**TOWNSHIP OF SOUTH WHITEHALL  
LEHIGH COUNTY, PENNSYLVANIA**

**PLANNING COMMISSION**

**APRIL 21, 2022**

**SUBJECT: DUNKIN ALLENTOWN DRIVE-THRU  
MAJOR PLAN 2021-105  
REQUEST FOR PRELIMINARY/FINAL PLAN REVIEW**

SHEET NUMBER  
**C-100 (3 OF 19)**

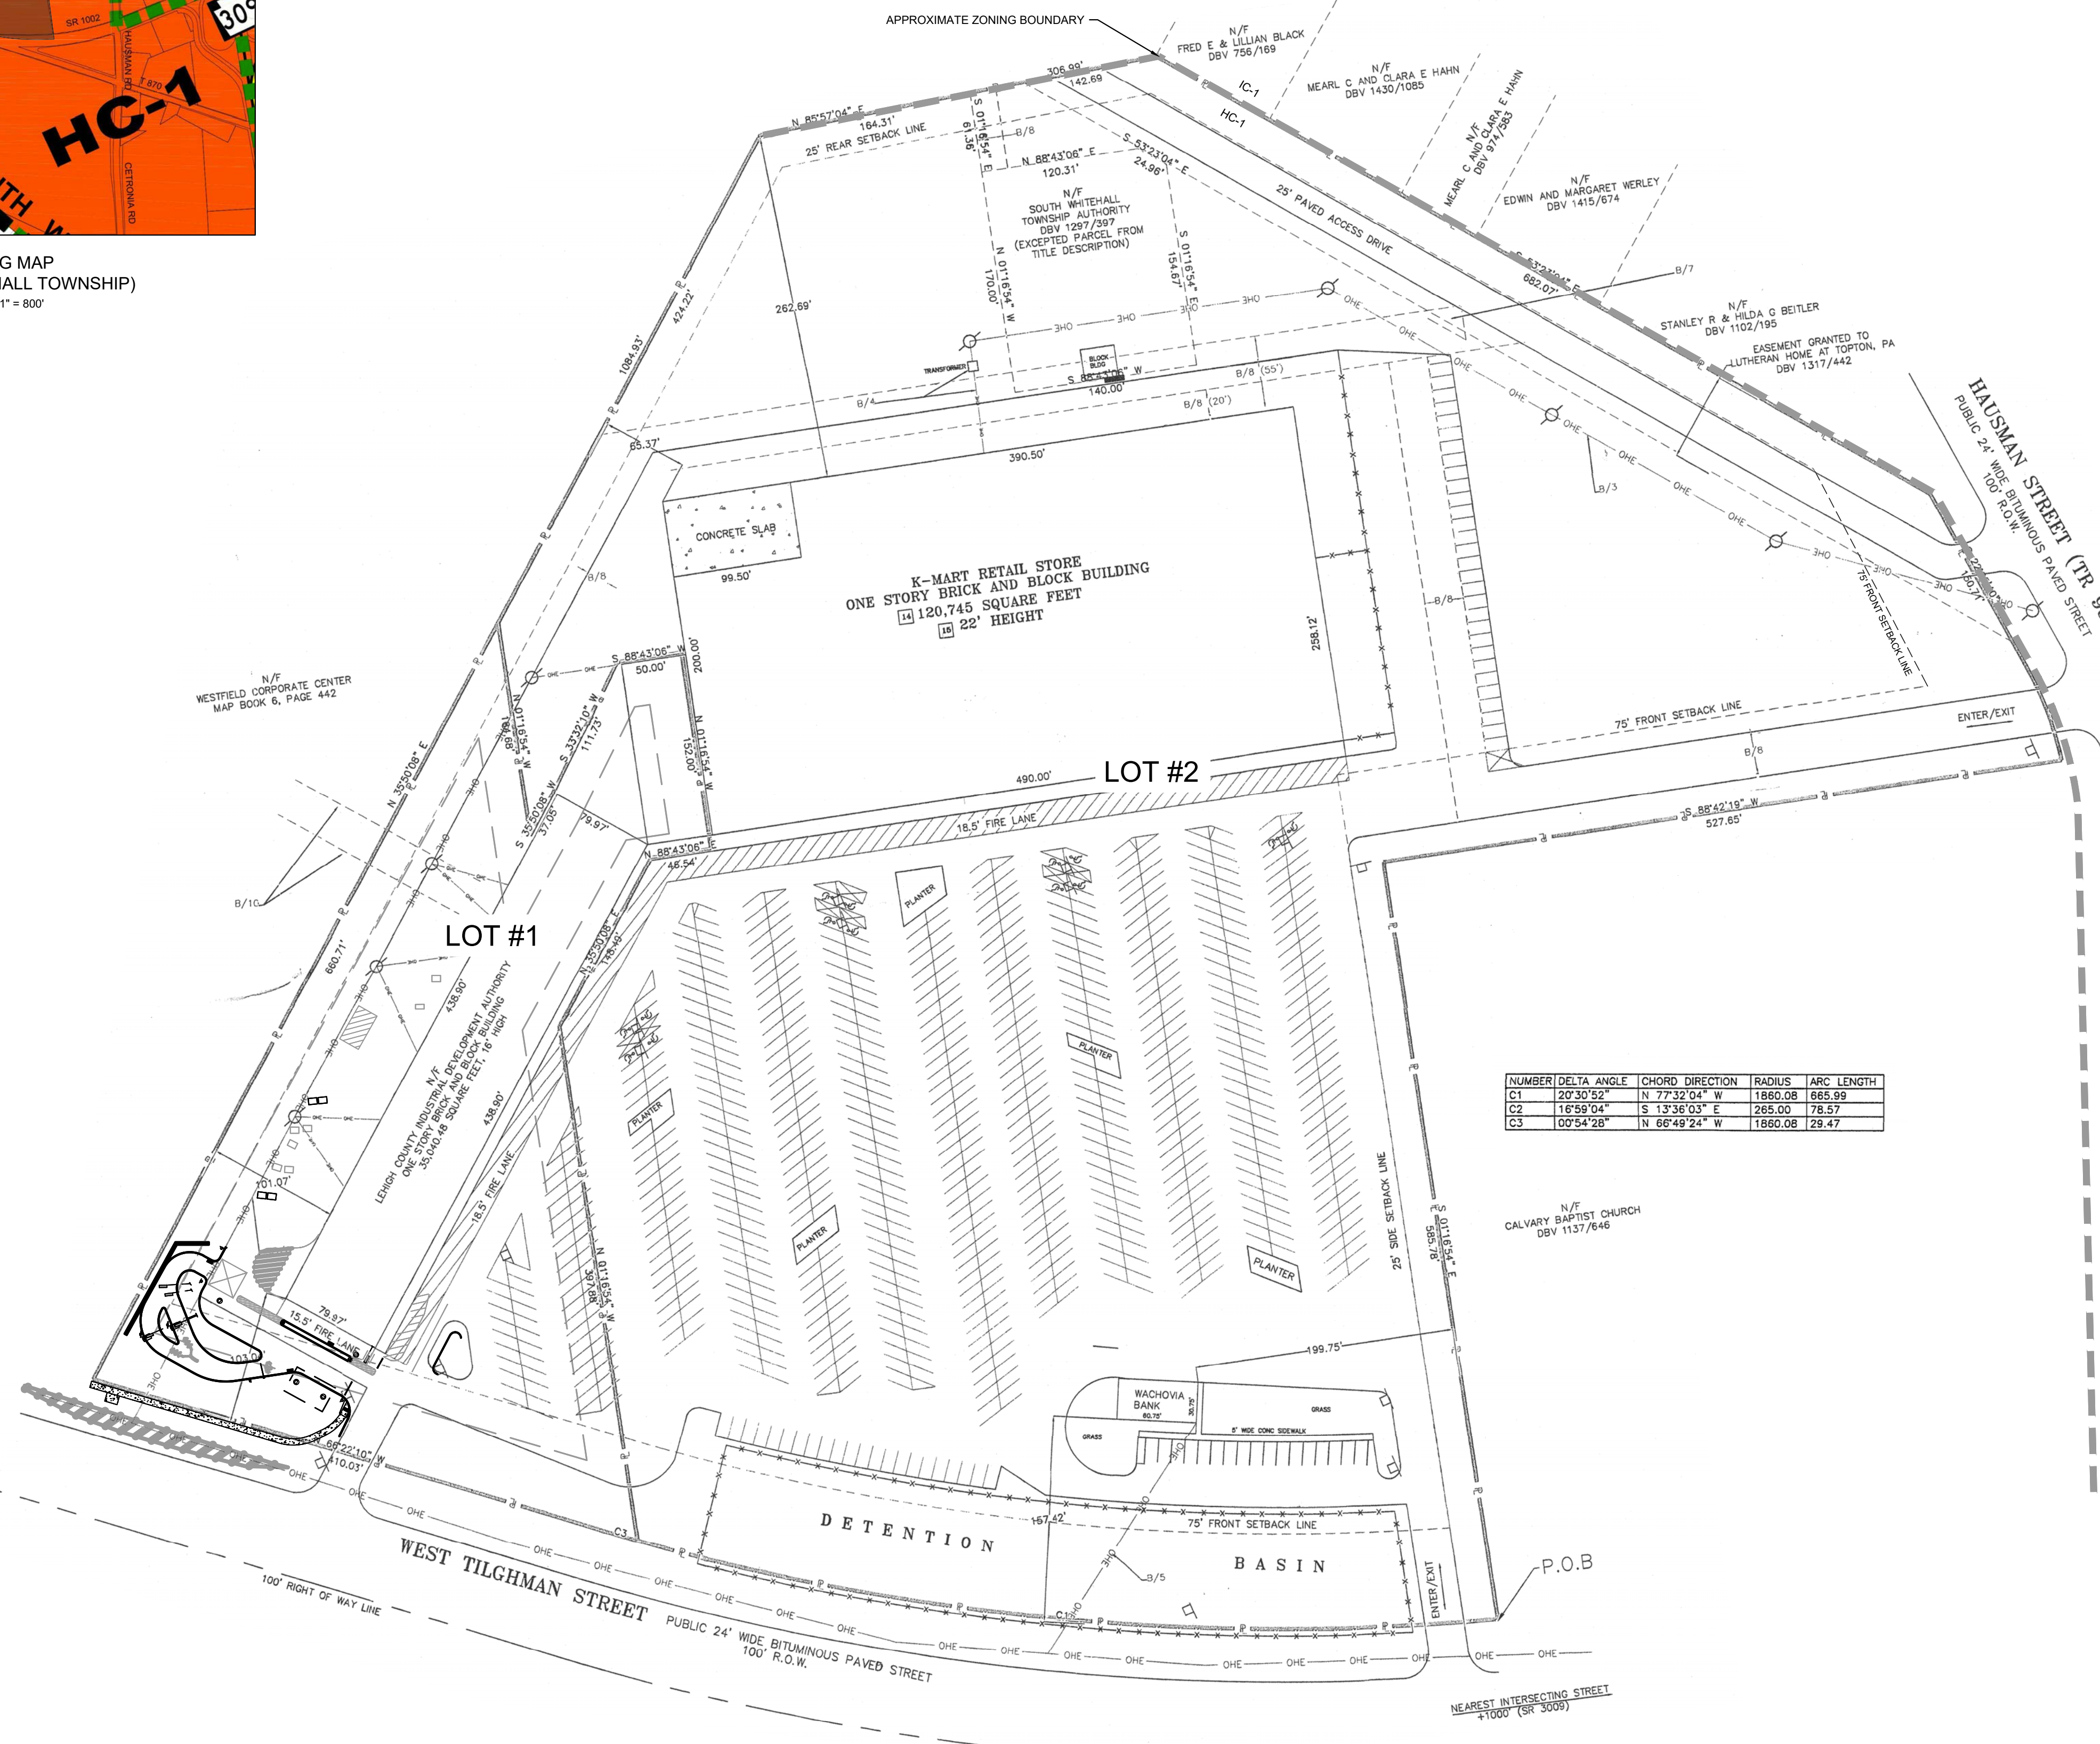
1. Provide concrete monuments in accordance with SALDO §312-36(f), §312-12(b)(27);
2. Provide complete/legible property boundary information on the Overall Site Plan (Sheet 3) for each lot and the entire site on the Plan (e.g., text along the boundary is obscured, Curve Table should be identified as such and expanded to include complete

SHEET NUMBER  
**C-200 (8 OF 19)**

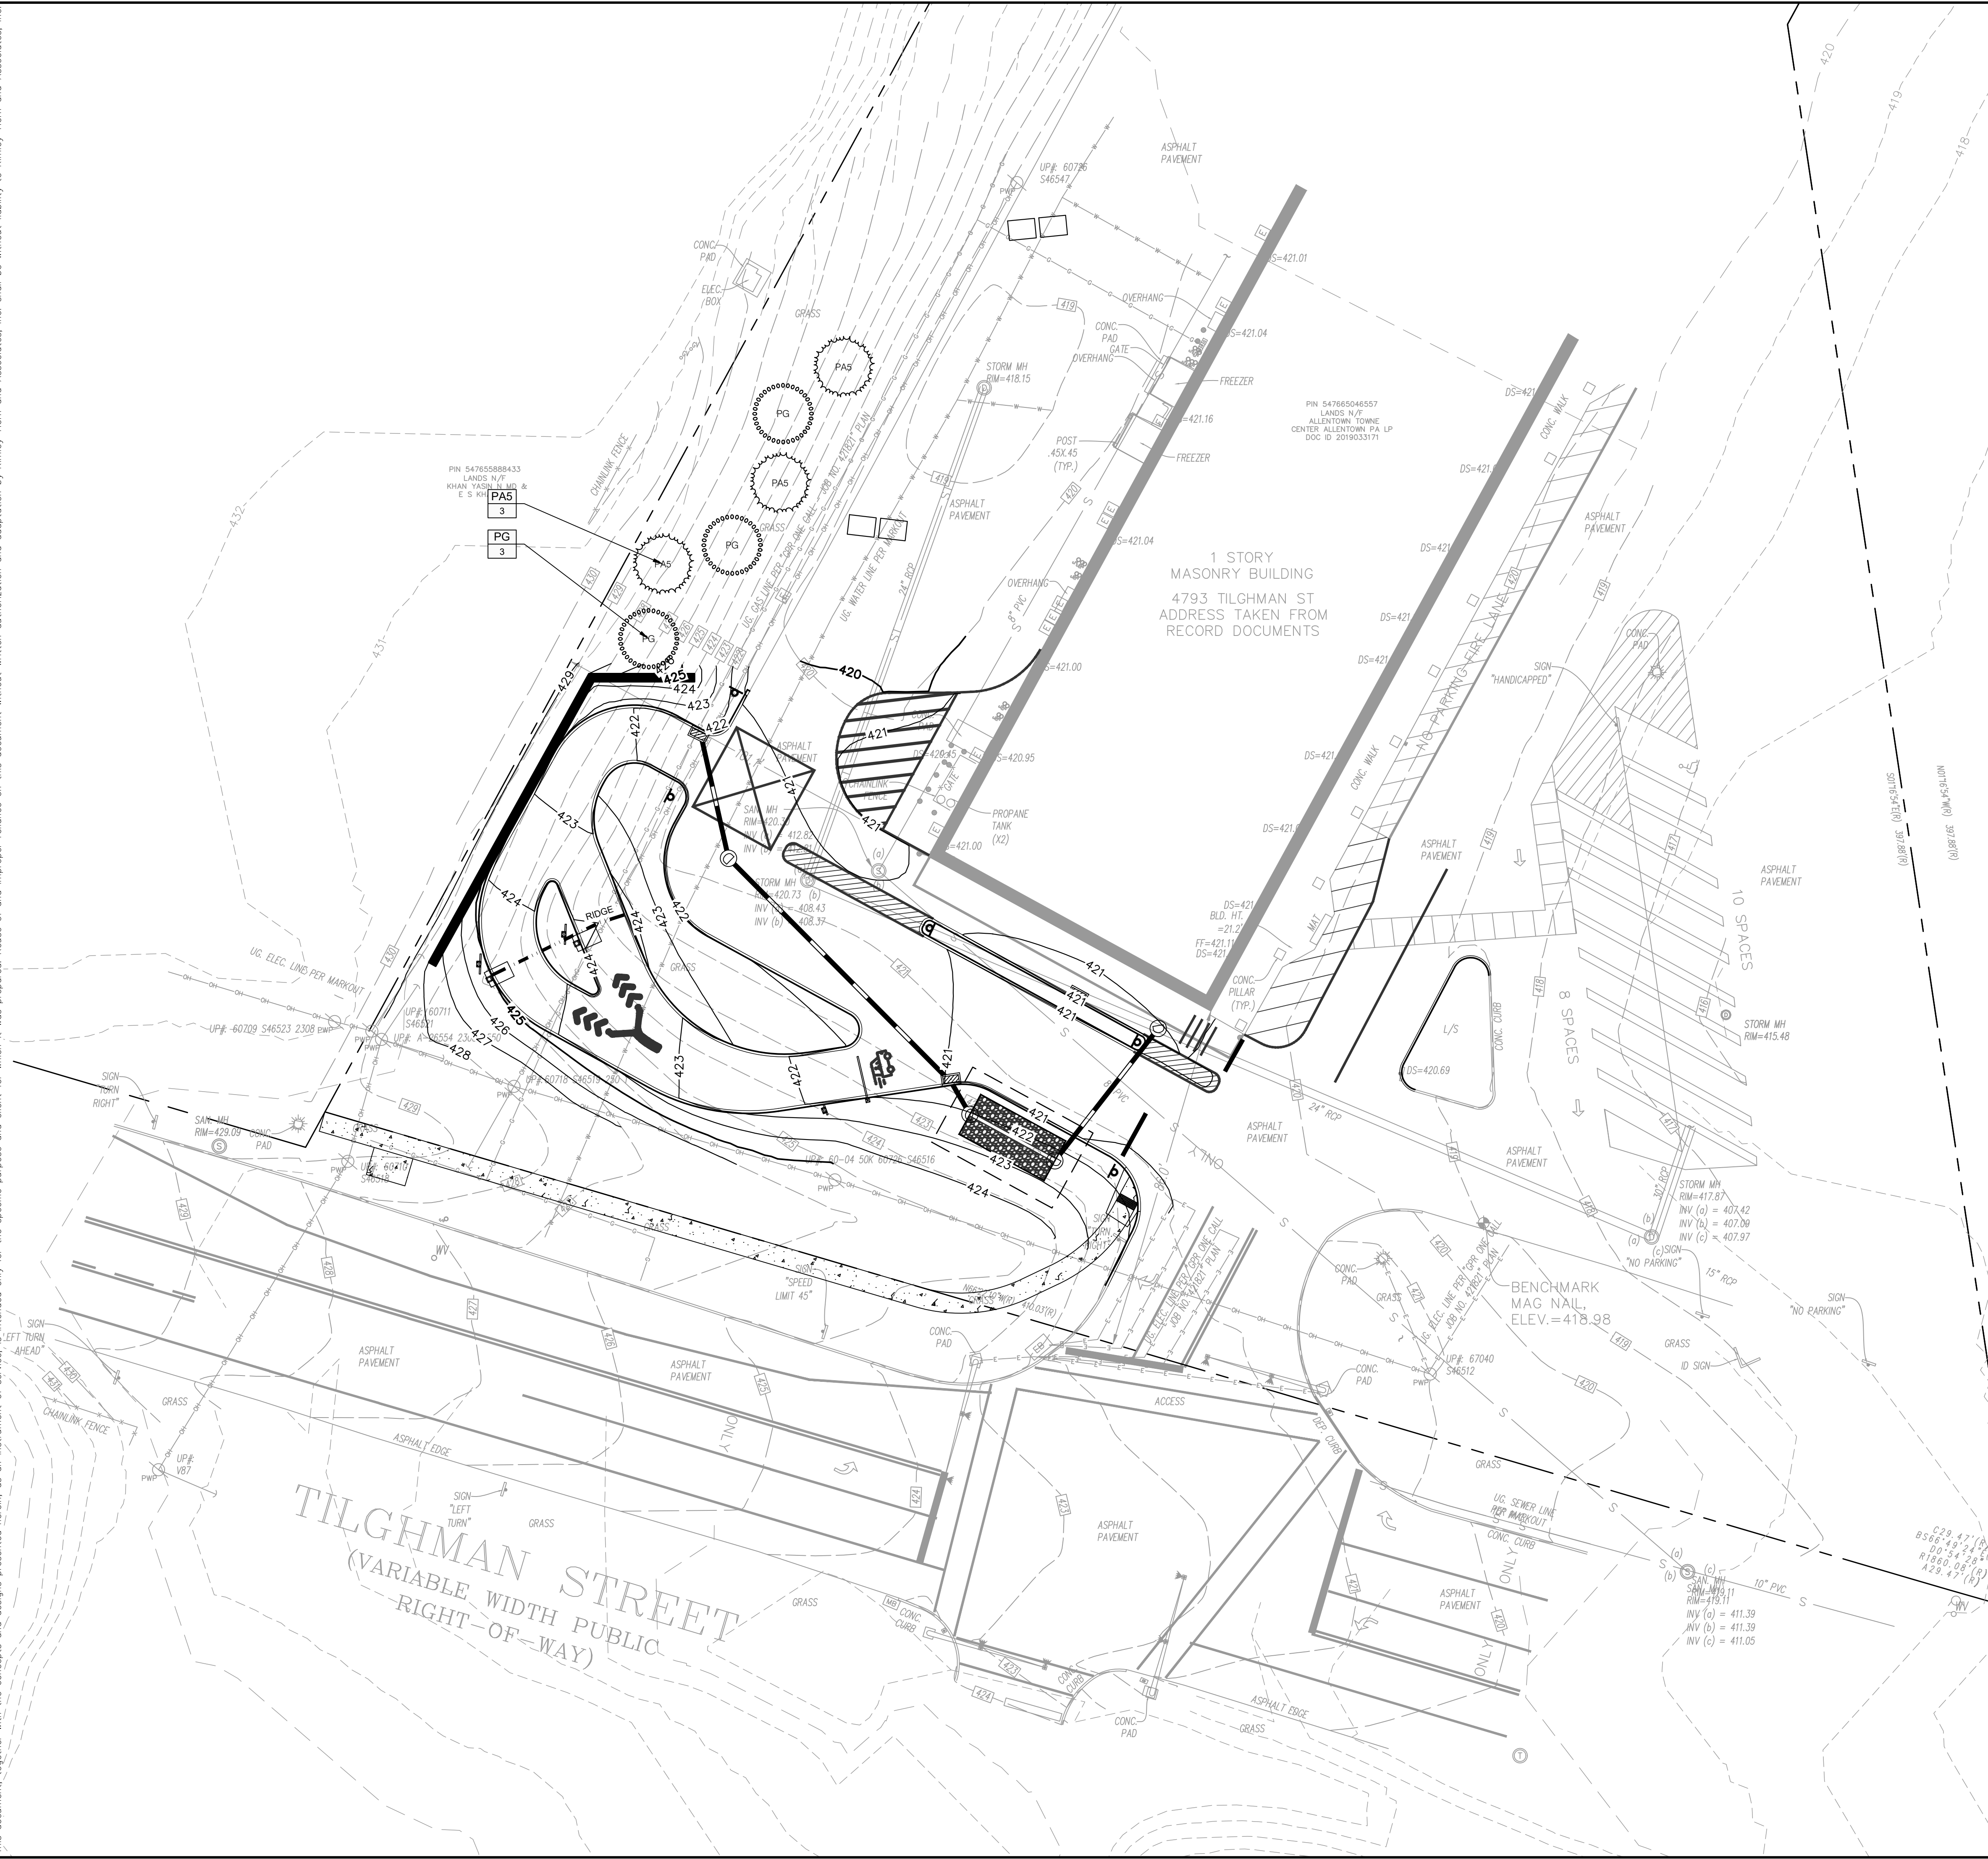
This comment has not been fully addressed. A soil data table is provided on Sheet 15. However, the soil boundary lines are not clearly shown on the plan.
